UNITED STATES PATENT AND TRADEMARK OFFICE

APPLICATION NO.	FILING DATE	FIRST NAMED INVENTOR	ATTORNEY DOCKET NO.	CONFIRMATION NO.
09/549,002	04/14/2000	Paul C. Hassler	7330*1	7995

Office Action Summary

Response to Amendment

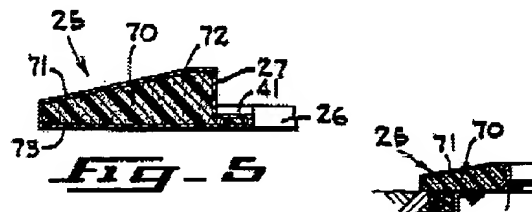
Shaftner discloses the claimed device except for the upper surface of the collar body being substantially planar. Grosh discloses that it is known in the art to provide an upper surface of a ramp member leading to a roadway structure to be substantially planar (see figure below). It would have been obvious to one having ordinary skill in the art at the time the invention was made to provide the ramp of Shaftner with the planar upper surface of Grosh, in order to allow for a flush fit, and therefore a smooth transition along the top of a grating or manhole cover.
